ASSESSMENT REPORT

Section 75W Modification

Fern Bay Seaside Village, Fern Bay, Port Stephens Local Government Area MP 06_0250 MOD 6

Figure 3: Comparison of Approved and Proposed Footpath/Cycleway

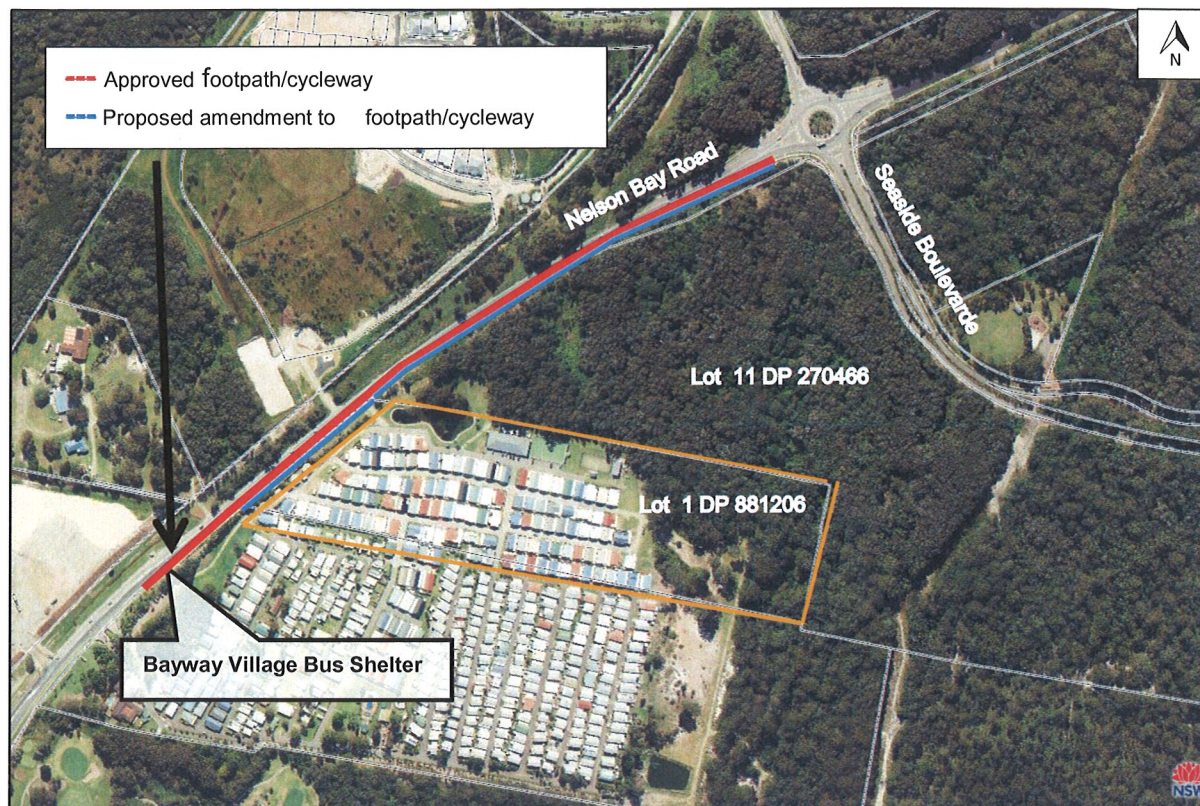
The Department notes that both the Council and the RMS support the revised wording of Condition B4, subject to the Proponent providing a road shoulder treatment for cyclists in the area between the end of the pathway and the bus shelter adjacent to the entrance of the

The Department has reviewed the Proponents justification and the comments provided by the Council and the RMS and agrees that it is not be possible for the Proponent to construct the section of the footpath/cycleway between Lot 1 in DP 881206 and the bus shelter at the entrance of the Bayway Village on the basis that the Proponent does not own this land (see **Figure 3**). In addition, the Department notes that to date neither the Council or the Proponent have been unable to acquire sufficient land to enable the construction of the portion of the footpath/cycleway south-east of Lot 1 in DP 881206.

Furthermore, the Department has concluded that in order to ensure cyclists can access the bus shelter at the Bayway Village the Proponent will need to construct a road shoulder treatment in the area between the end of the pathway and the bus shelter adjacent to the entrance of the Bayway Village.

Given the above, the Department considers that the proposed modifications to Condition B4 will ensure that the footpath/cycleway is constructed to the maximum possible extent within the project area. In addition, the Department supports deferring the timing for the construction of the footpath/cycleway to ensure that the Proponent has sufficient time to consult with the Council and the RMS on the final design of the path.

The Department has recommended modifications to Condition B4 to reflect the above.
